UNITED STATES PATENT AND TRADEMARK OFFICE

APPLICATION NO.	FILING DATE	FIRST NAMED INVENTOR	ATTORNEY DOCKET NO.	CONFIRMATION NO.
10/816,696	04/01/2004	An Hien Lam	200313894-1	9710

Office Action Summary

DETAILED ACTION

FIGURE 1

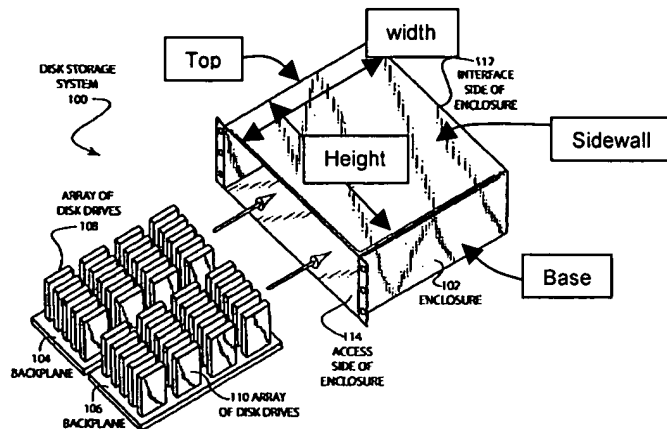
- Regarding claim 5, El-Batal et al. further discloses that the enclosure has a height and said plane portions have respective heights, and wherein the collective height of the plane portions is about equal to the enclosure height (see attached figure).
- Regarding claim 6, El-Batal et al. further discloses that the enclosure has a height and said plane portions have respective heights, and wherein the collective height of the plane portions is about equal to the enclosure height, and wherein the plane portion heights are about equal to one another (see attached figure).

- Regarding claim 12, El-Batal et al. discloses a system comprising an enclosure (102) comprising a base, a top and a pair of sidewalls (marked in attached figure) joined with and extending between the base and top to define an interior volume within which multiple pluggable devices (110) can be received, the enclosure having a front and a back (figure 4); a first back plane portion (104) mounted within the enclosure and comprising multiple connectors; and a second back plane portion (106) mounted within the enclosure and comprising multiple connectors, the second back plane portion being spaced apart from the first back plane portion effective to define a gap that allows air entering from the front of the enclosure to escape at the back of the enclosure (paragraph 0028).

2. Claim 15 is rejected under 35 U.S.C. 103(a) as being unpatentable over El-Batal et al. El-Batal et al. disclose all the limitation of claim 12. Although figure 1 of El-Batal et al. indicates that the width of the gap region is equal to or greater than the height of the enclosure (dimensions marked in attached figure), they do not explicitly disclose that gap width between the first and second back plane portions is no less than about one half of the enclosure height. If it is not already so, It would have been obvious to one of ordinary
